DESIGN COMMISSION REGULAR VIDEO MEETING AGENDA

STAFF REPORT

DESIGN COMMISSION FINDINGS OF FACT AND CONCLUSIONS OF LAW

Project No.:	DSR21-012
Description:	A request for design review approval to renovate an existing gas station in the Town Center.
Applicant / Owner:	Brad Kaul (Kaul Design Architecture, PLLC) / Matt Randish
Site Address:	7833 SE 28th Street, Mercer Island, WA 98040, identified by King County Assessor's tax parcel number 5452300380.
Zoning District	Town Center (TC)
Staff Contact:	Ryan Harriman, EMPA, AICP – Planning Manager
Exhibits:	<ol style="list-style-type: none"> 1. Development Application, received on October 6, 2021 2. Notice of Application, dated January 24, 2022 3. Plan Set, received on December 21, 2021 4. Project Narrative, received on December 21, 2021 5. SEPA Checklist, dated March 5, 2021 (See SUB2 for SEP20-025) 6. Mitigated Determination of Nonsignificance, issued by the City of Mercer Island on September 27, 2021 7. Arborist Report prepared by Tree133 LLC, dated October 20, 2020 8. Transportation and Civil Engineering Trip Generation Report prepared by Heath and Associated, Inc, dated October 15, 2020 9. Study Session Feedback and Applicant Respons

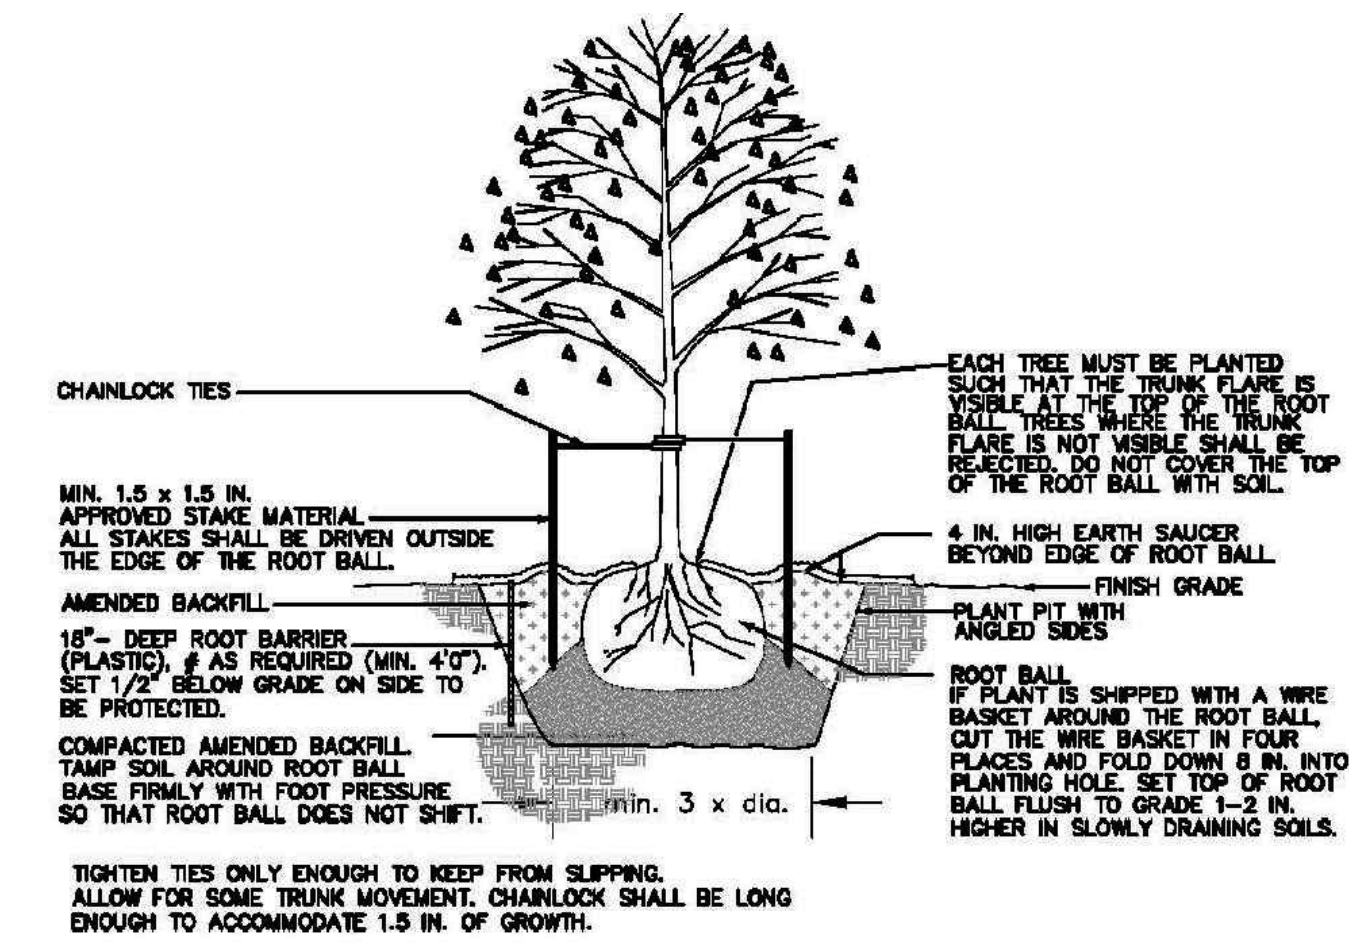
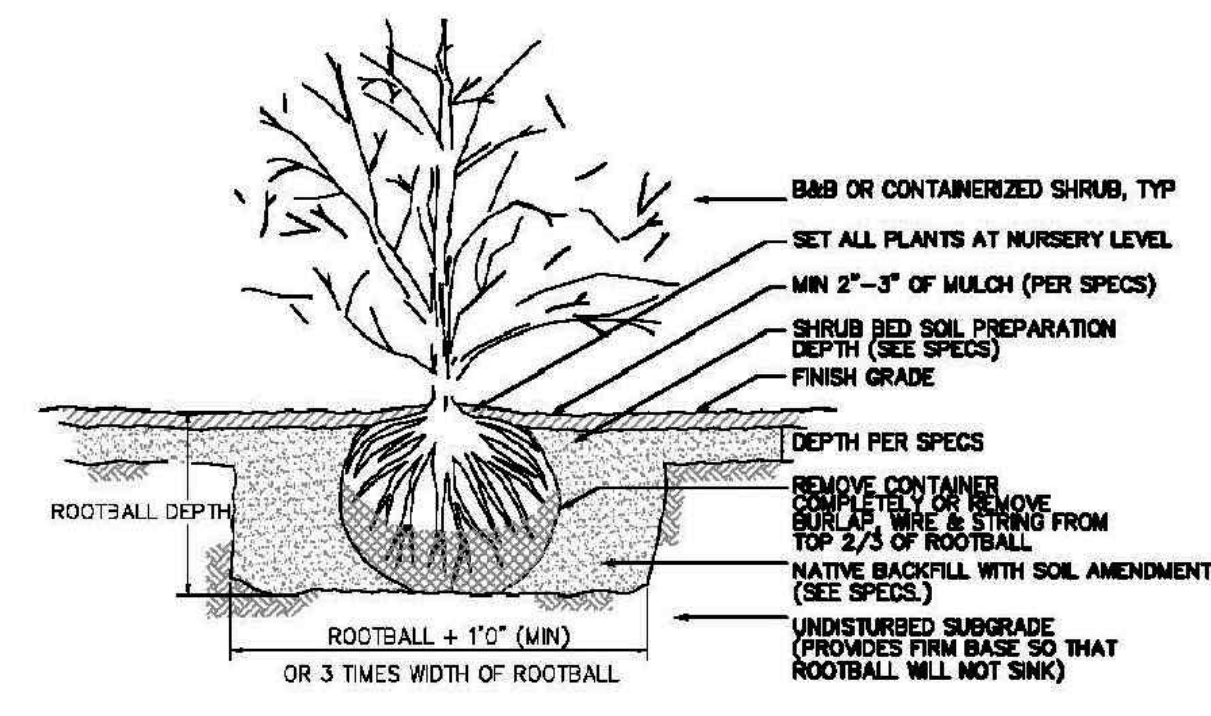
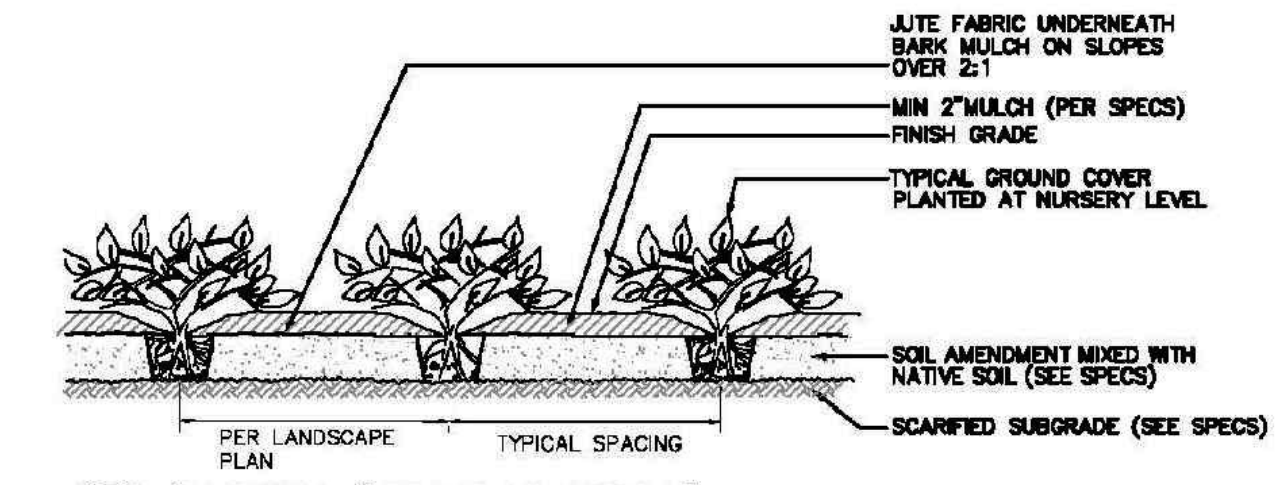
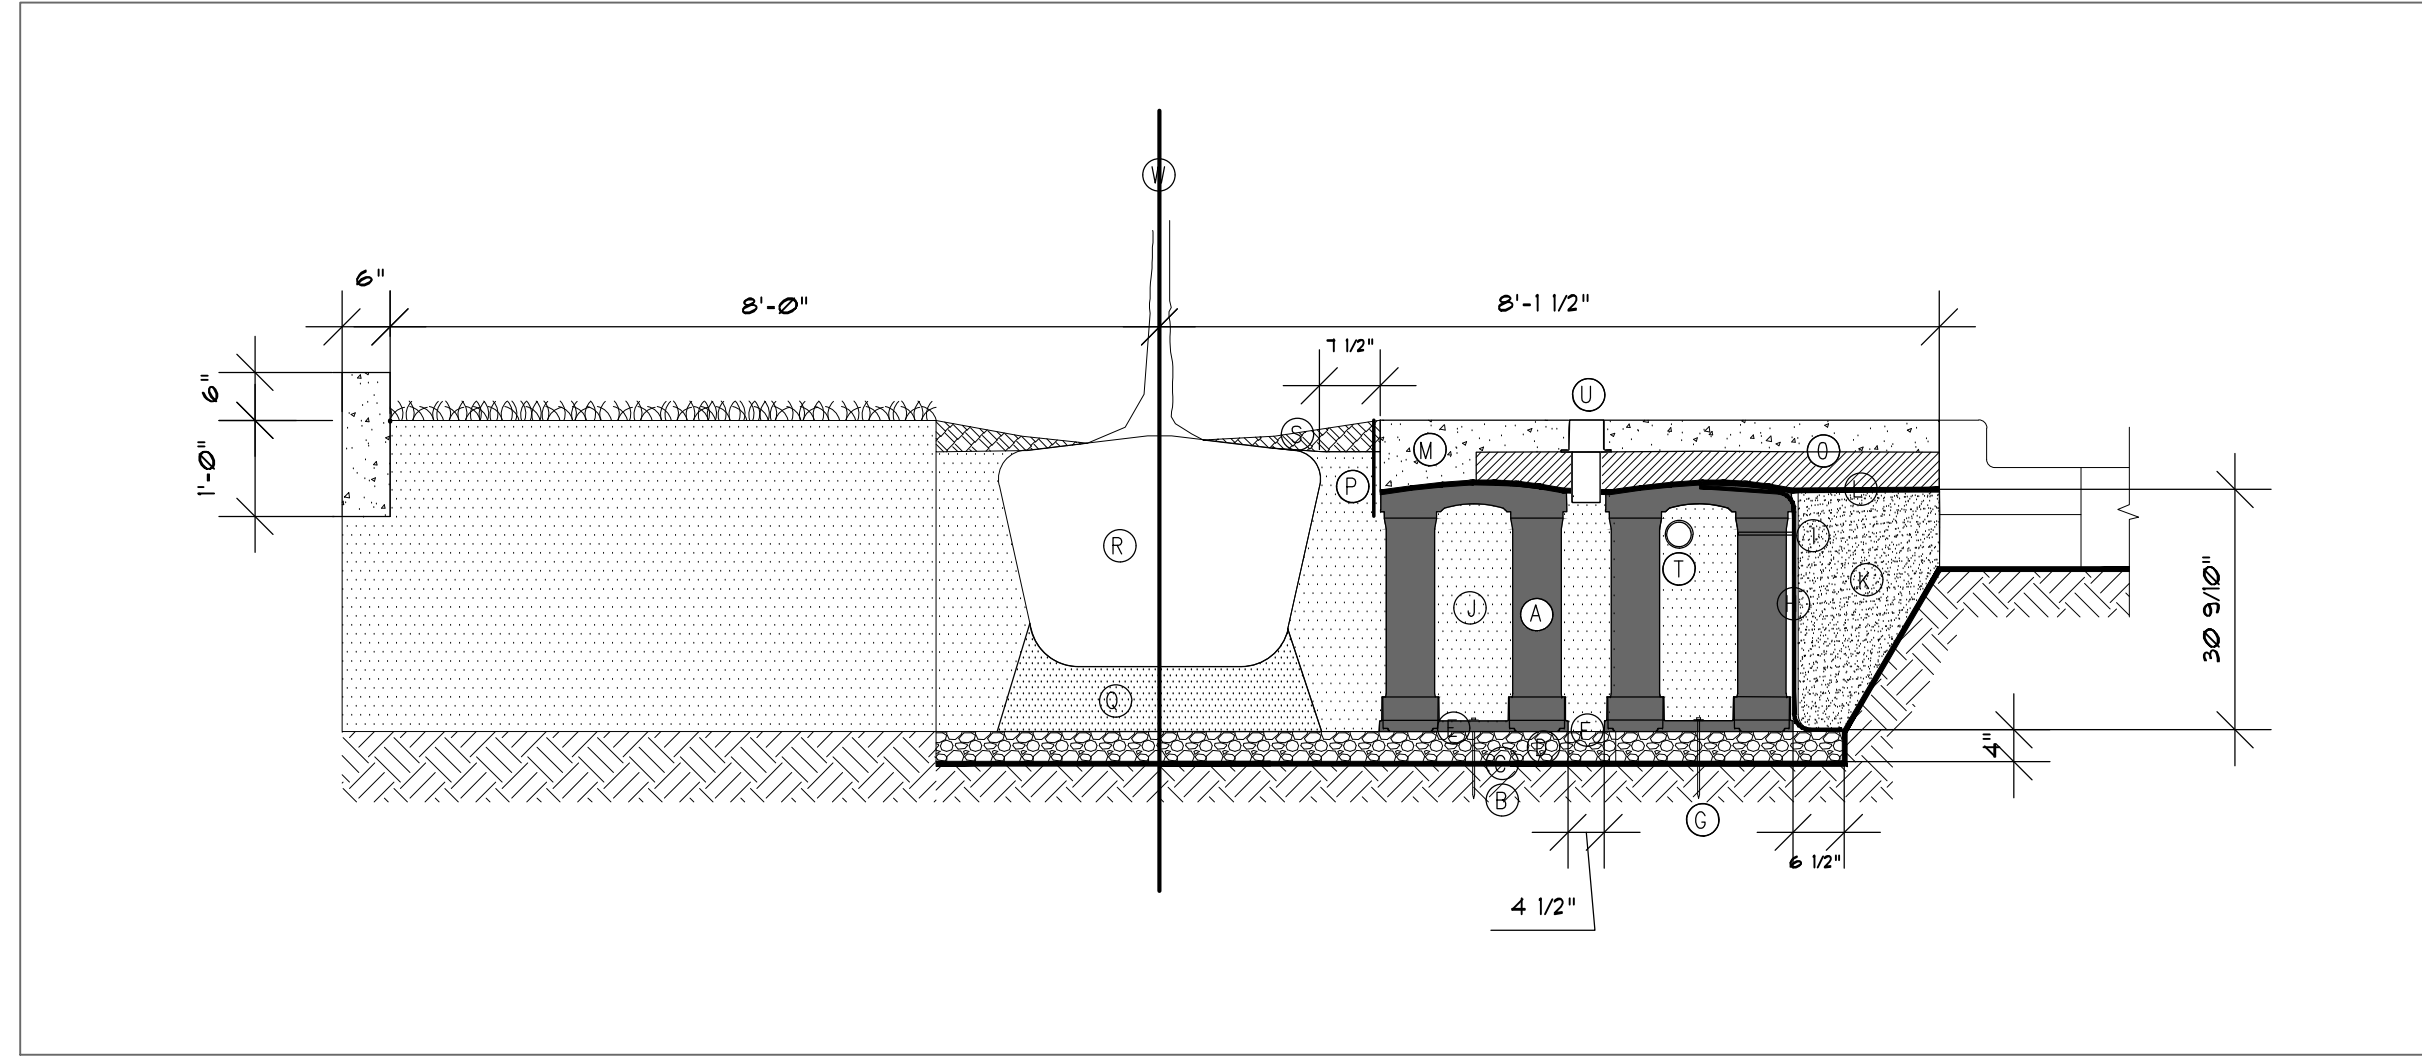
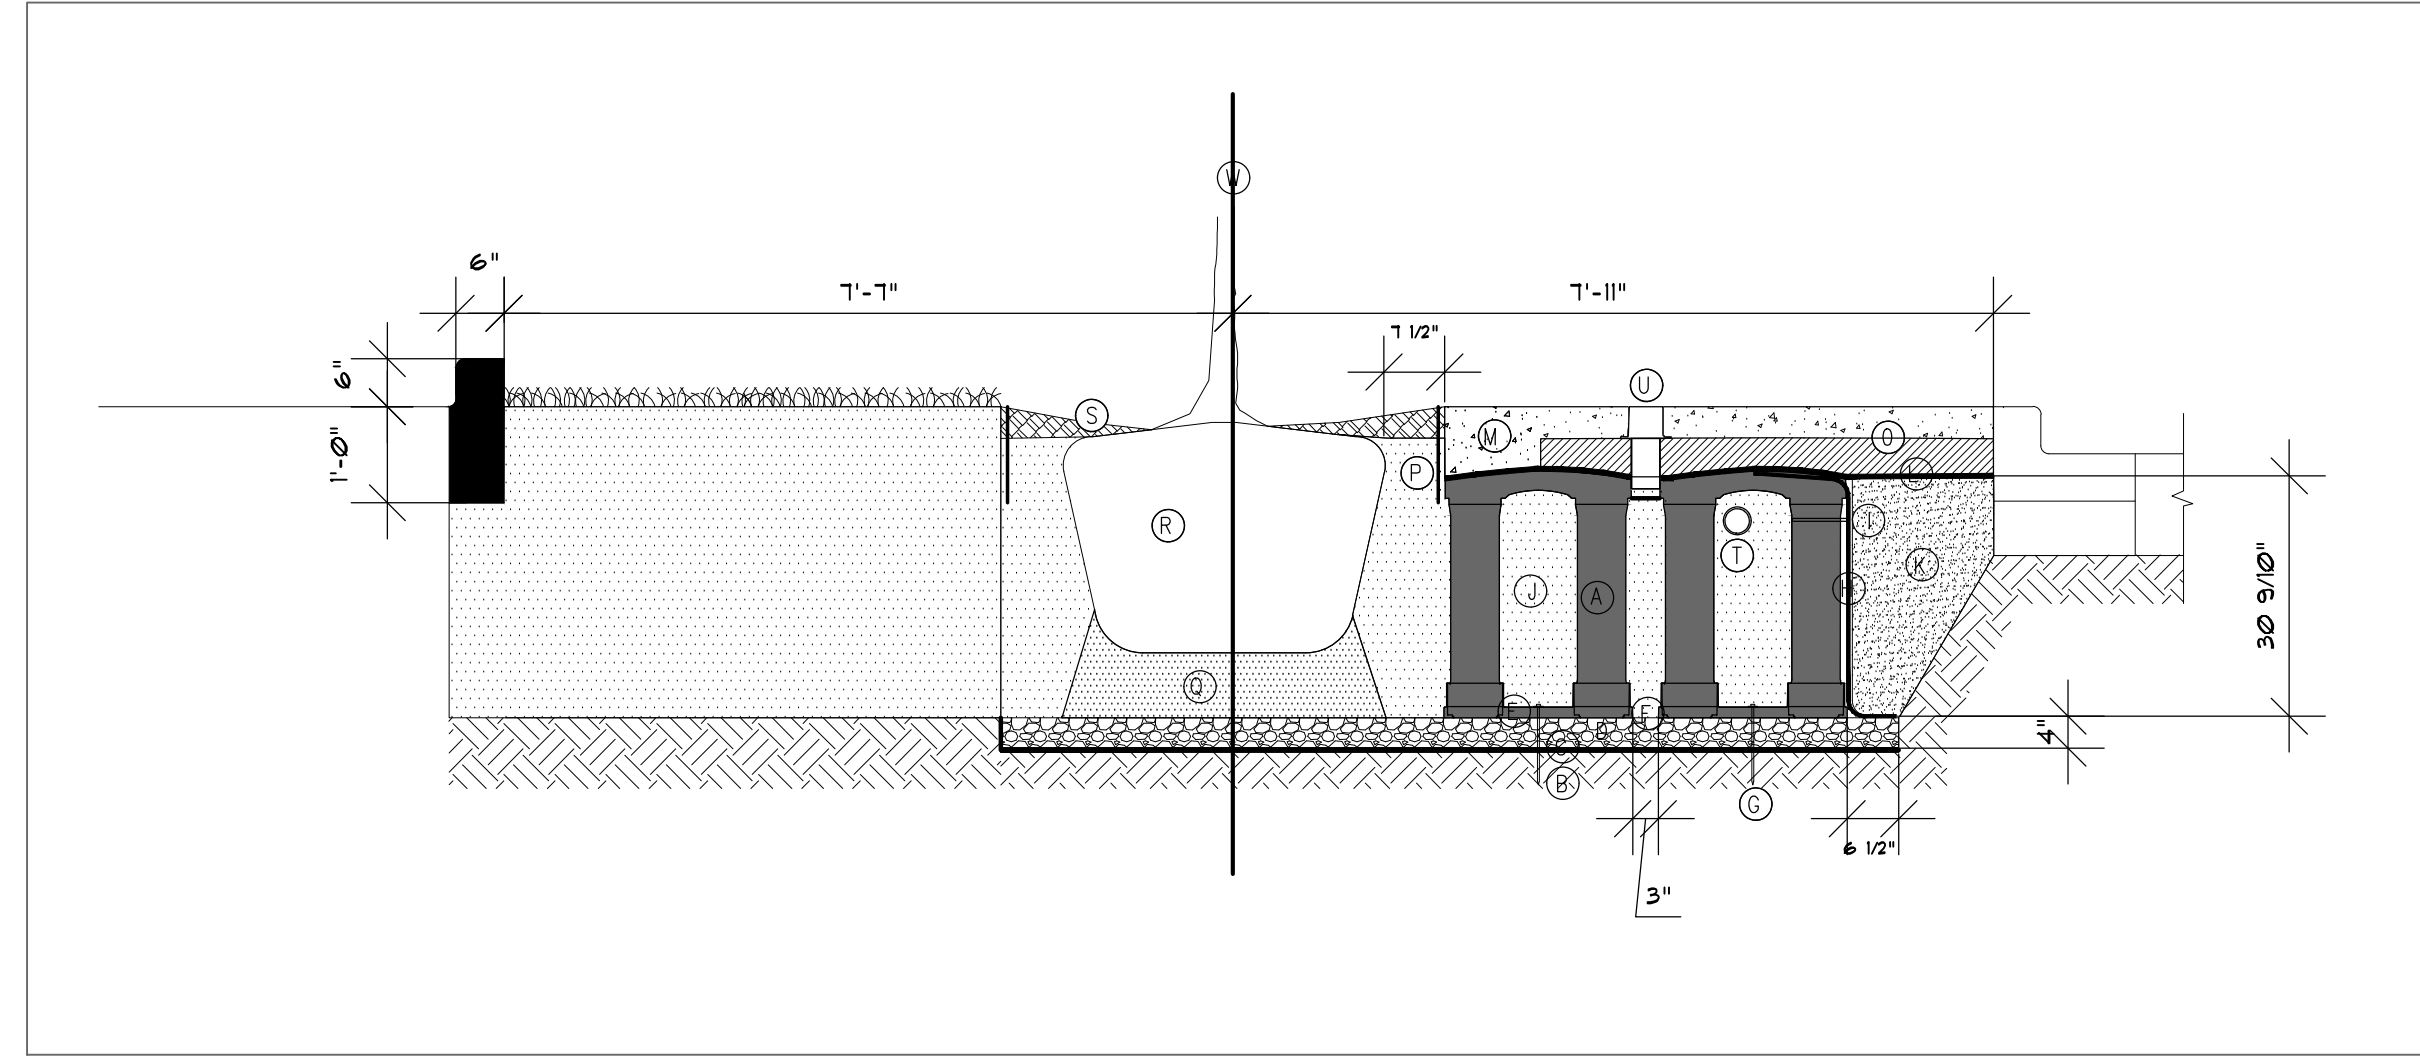
Staff Finding: The existing street trees will need to be removed as part of the clean-up. Trees will be replanted as part of the proposal. Please refer to the landscaping plans located on sheets **L1-L3 in Exhibit 3**.

Staff Finding: The proposed development is consistent with the soil quality, depth, and volume requirements. Please refer to the landscaping plans located on sheets **L1-L3 in Exhibit 3**.

Staff Finding: The existing landscaping between properties will remain while adding to the existing landscaping strip between this parcel and the QFC. Please refer to the landscaping plans located on sheets **L1-L3 in Exhibit 3**.
